TECHNICAL INFORMATION

68117
(Page 1 of 2)

Subject ▶ Change of Blade Clamping System and Shoe

For Models ▶ JR140D, JR180D

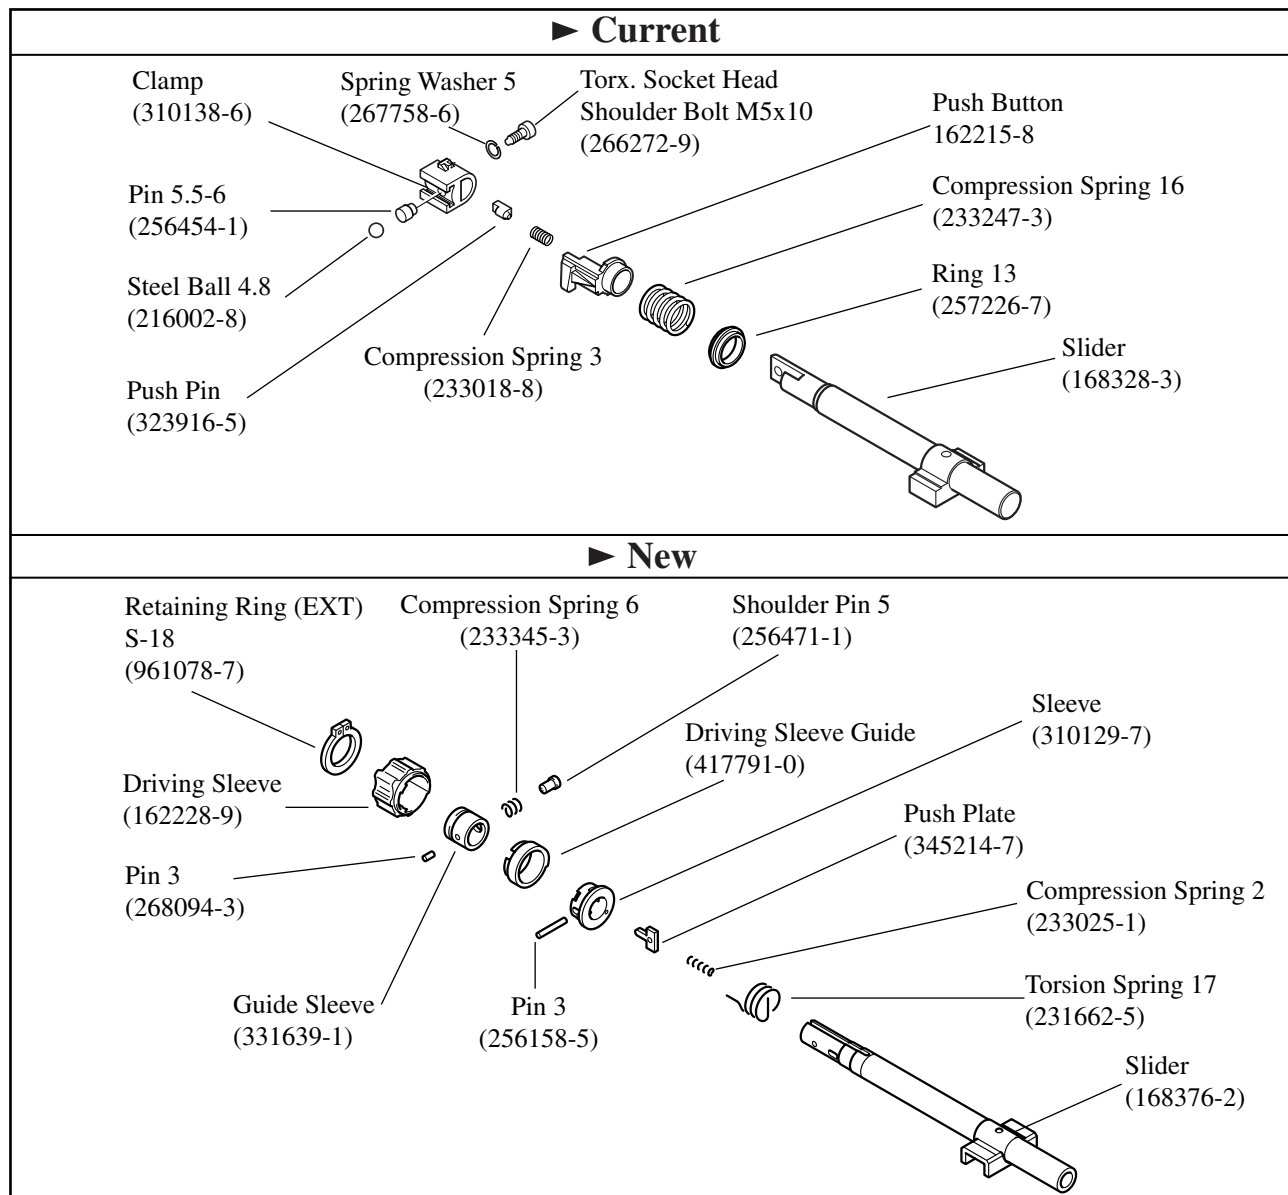
1) The following changes have been implemented to make the tool-less blade change system more durable.

2) Shoe has been changed as shown below.

▶ Current	▶ New
For European countries except U.K.	Shoe (168337-2)	Shoe (163441-2)
For the other countries	<div style="display: flex; flex-direction: column; align-items: center;"> </div>	<div style="display: flex; flex-direction: column; align-items: center;"> </div>

Item No.	Current part		Q'ty	I/C	New part		Q'ty	Note
014	Slider 168328-3		1	No	Slider 168376-2		1	Interchangeable as a set
011	Ring 13 257226-7		1					
010	Compression Spring 16 233247-3		1					
009	Compression Spring 3 233018-8		1					
008	Push Pin 323916-5		1					
007	Push Button 162215-8		1					
004	Pin 5.5-6 256454-1		1					
003	Steel Ball 4.8 216002-8		1					
006	Torx. S. H. Shoulder Bolt M5x10 266272-9		1					
082	Spring Washer 5 267758-6		1					
005	Clamp 310138-6		1					
088					Guide Sleeve 331639-1		1	
091					Sleeve 310129-7		1	
090					Pin 3 256158-5		1	
089					Driving Sleeve Guide 417791-0		1	
092					Push Plate 345214-7		1	
086					Driving Sleeve 162228-9		1	
087					Pin 3 268094-3		1	
083					Shoulder Pin 5 256471-1		1	
085					Retaining Ring (EXT) S-18 961078-7		1	
084					Compression Spring 6 233345-3		1	
093					Compression Spring 2 233025-1		1	
094					Torsion Spring 17 231662-5		1	
017	Shoe 168337-2		1	No	Shoe 163441-2		1	For Europe except U. K.

017	Shoe Plate 344801-9		1	No	Shoe 163442-0		1	For the other countries.
022	Shoe Supporter 344925-1		1					
021	Hex. Socket Head Bolt M5x50 266241-0		1					
019	Hex. Lock Nut M5-8 252103-8		1					
078	Spring Washer 5 942101-7		1
